**CEP Level 1**

REVISED 06/25/2015

**ATTACHMENT 2-  
FLOORPLANS - PAGE 1 OF 4  
FIRST FLOOR PLAN: CEP**

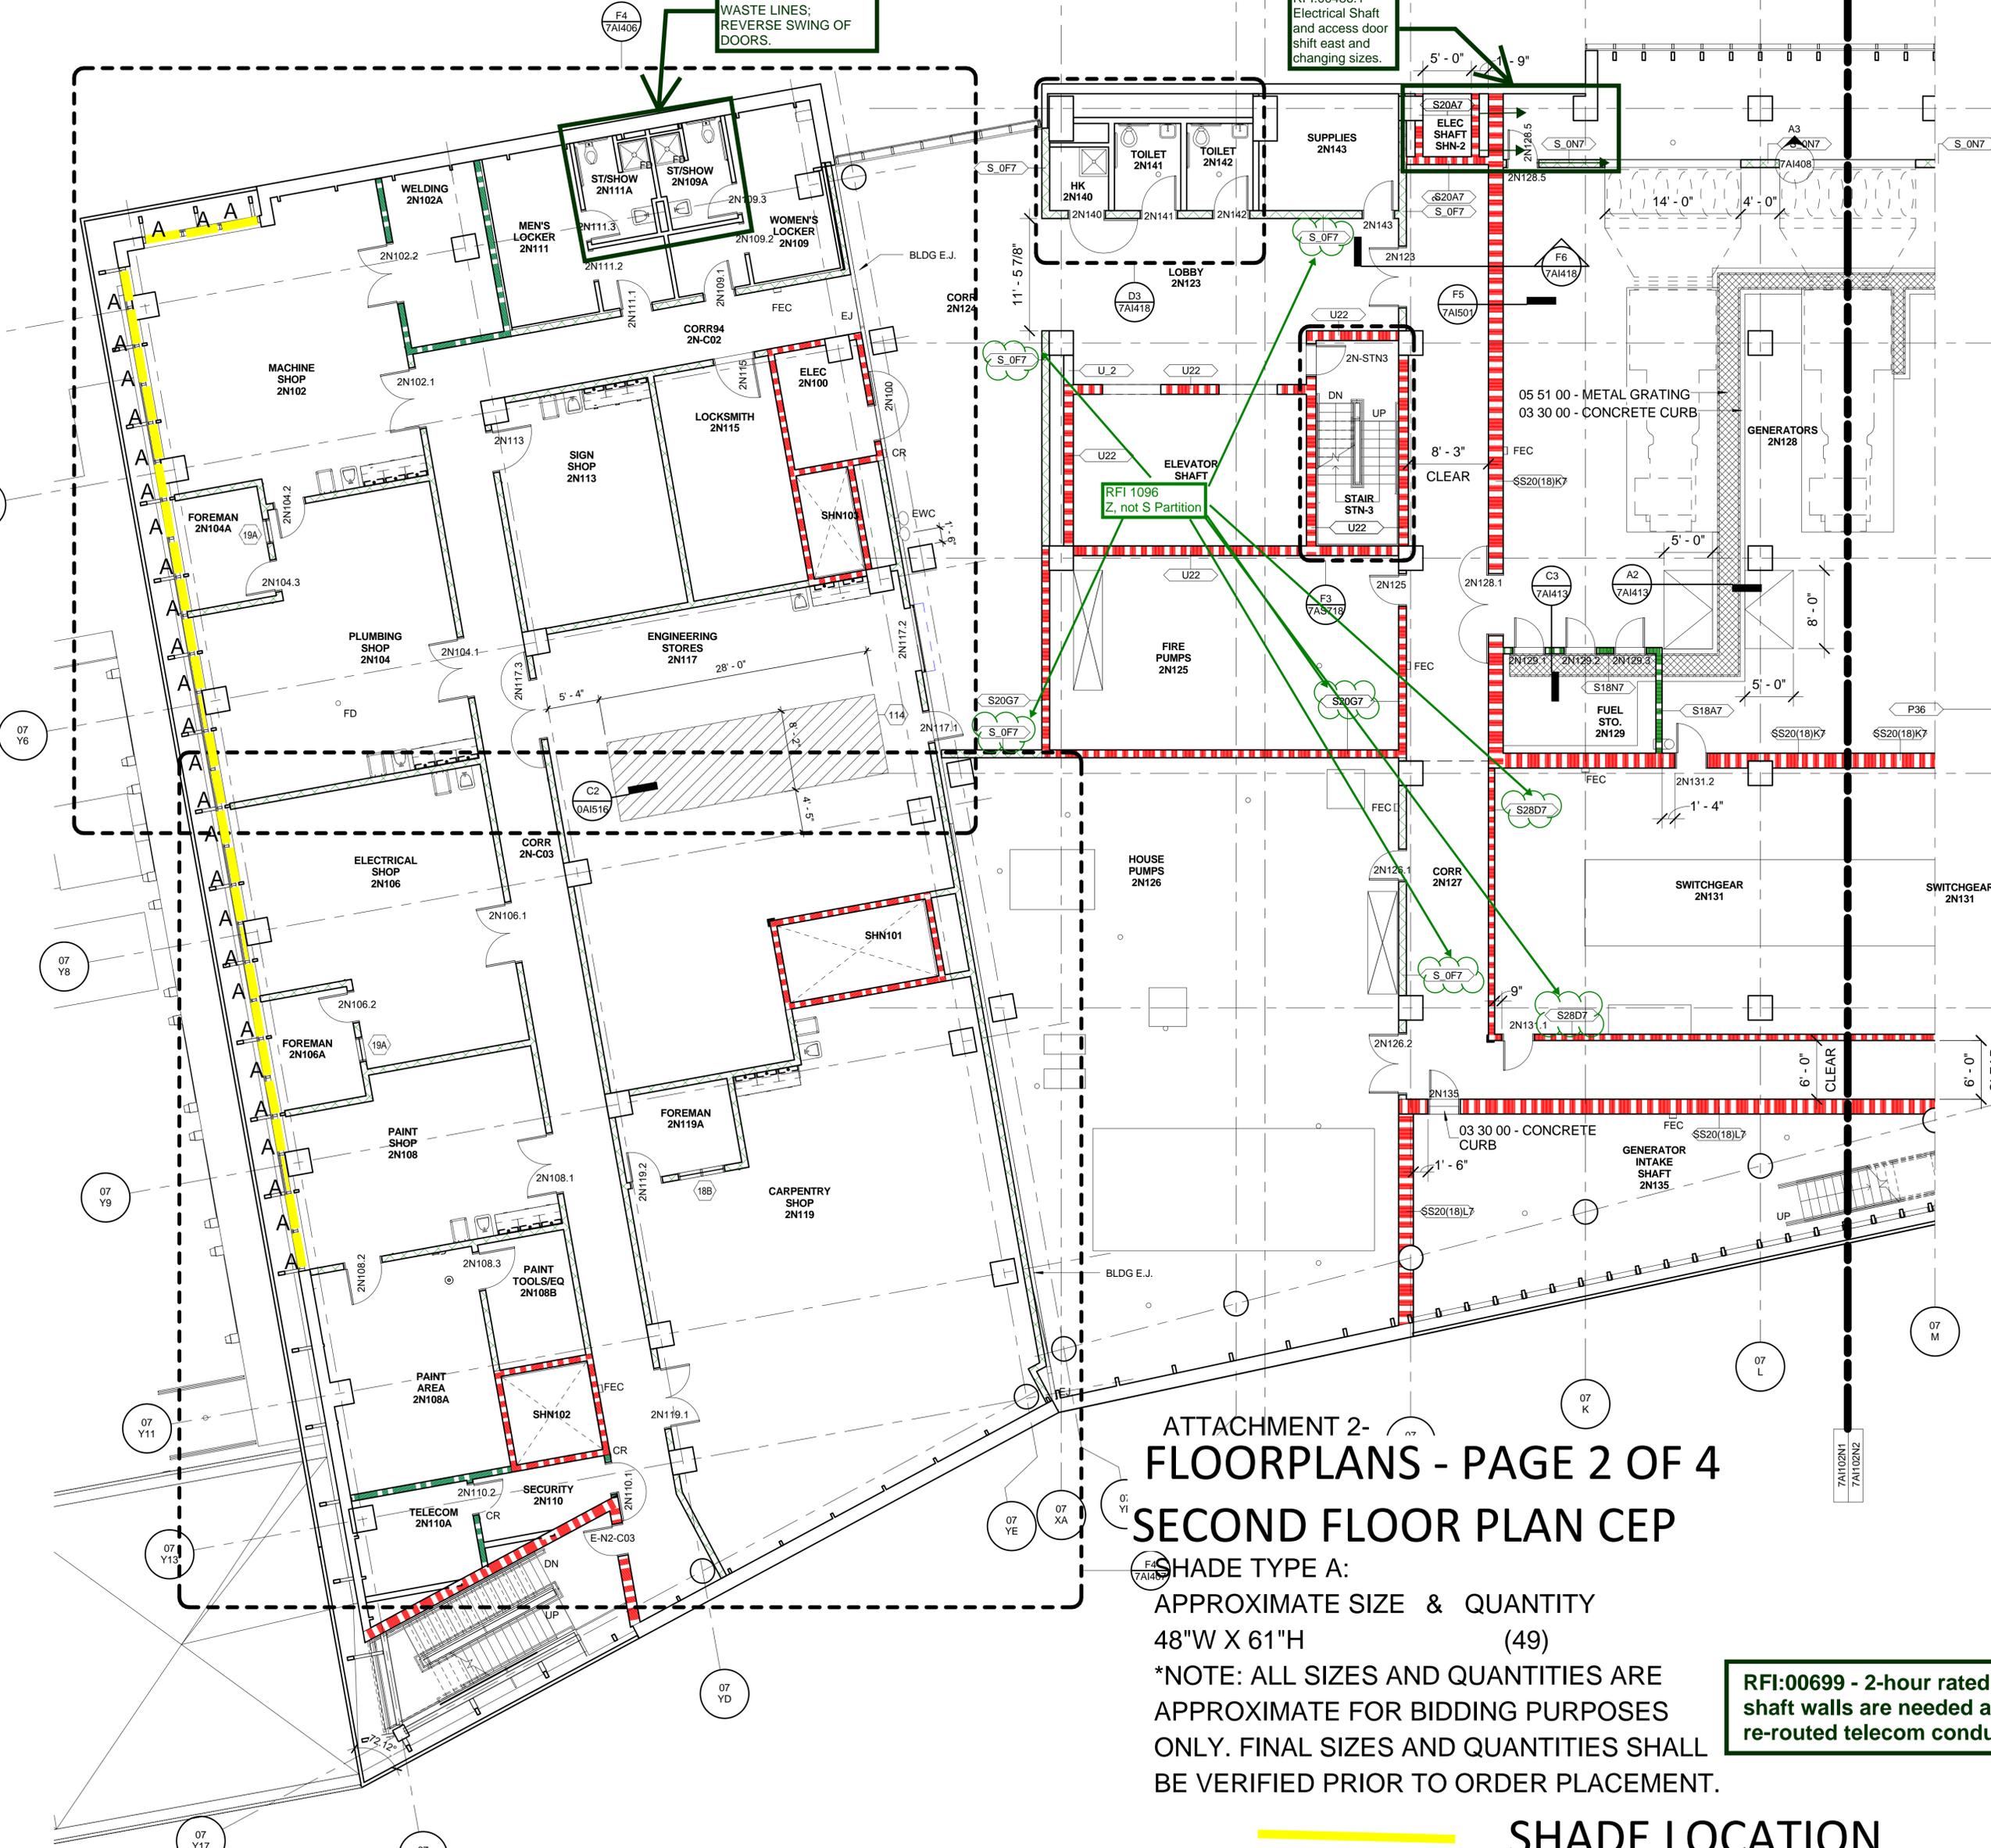
WASTE LINES:  
REVERSE SWING OF  
DOORS.

Electrical Shaft  
and access door  
shift east and  
changing sizes.

ATTACHMENT 2-  
FLOORPLANS - PAGE 2 OF 4  
SECOND FLOOR PLAN CEP

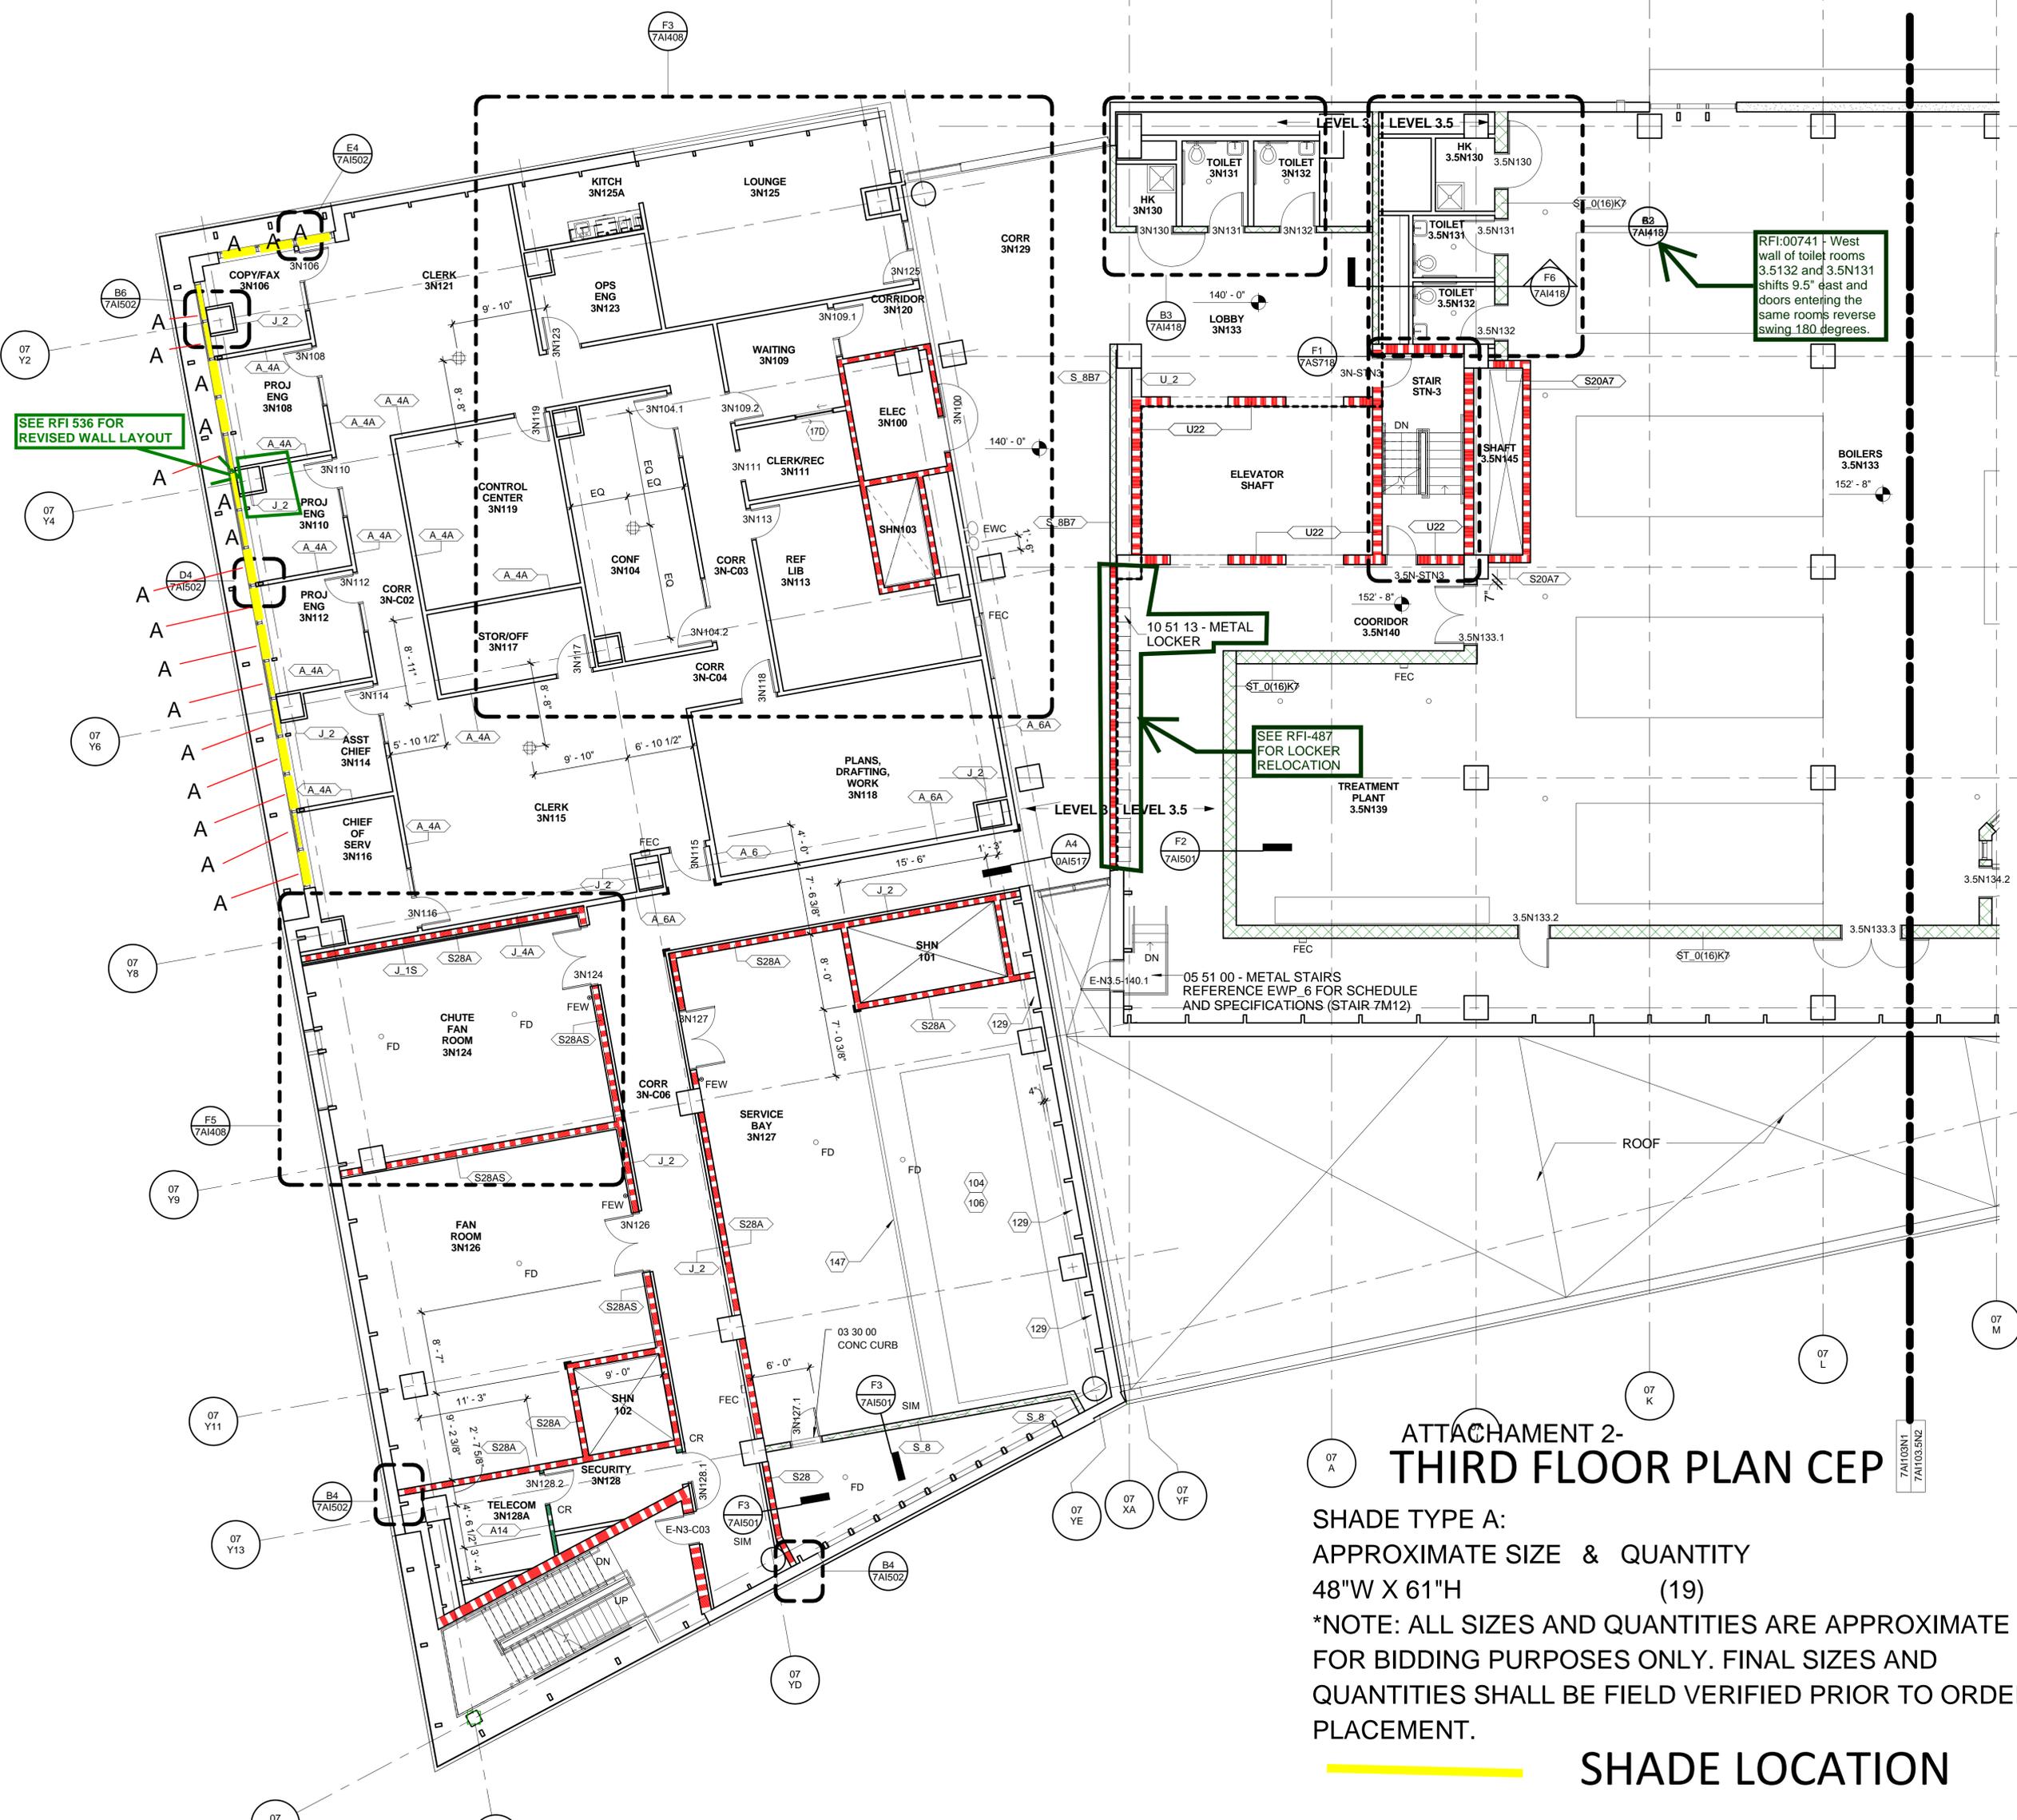
RFI:00699 - 2-hour rated  
shaft walls are needed a  
re-routed telecom condu

## ATTACHMENT 2- THIRD FLOOR PLAN CEP

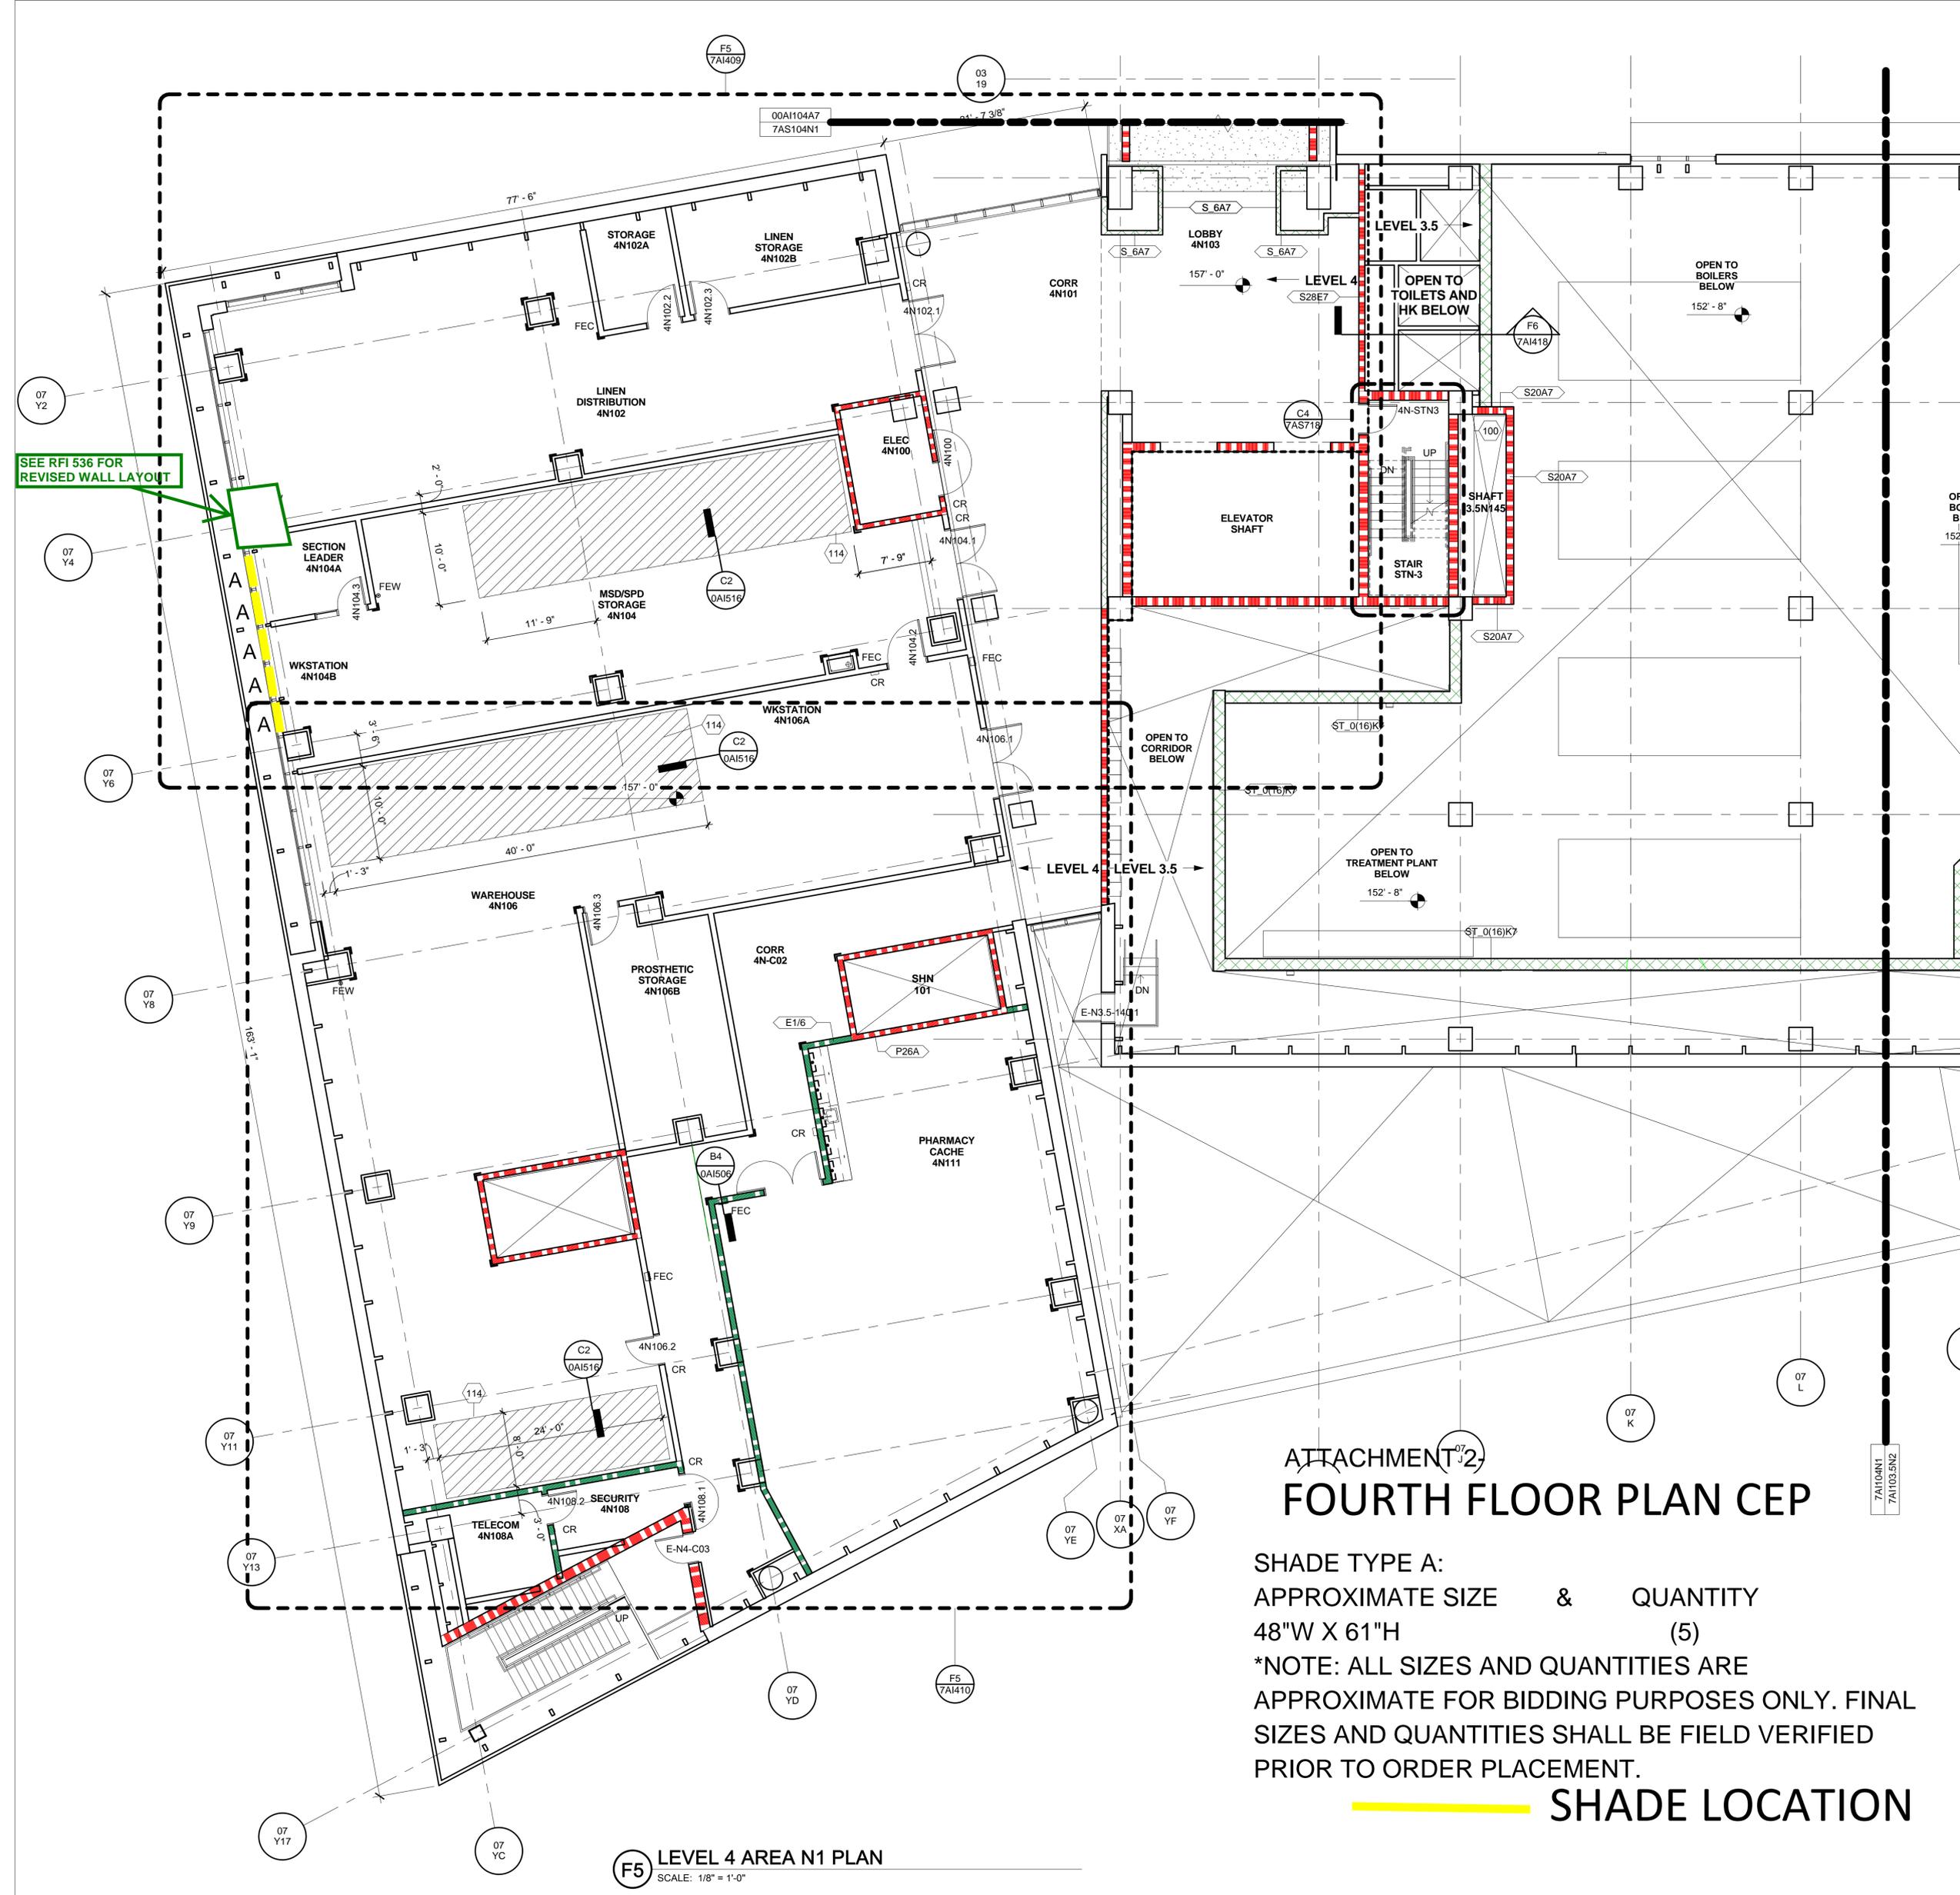
SEE RFI 536 FOR REVISED WALL LAYOUT
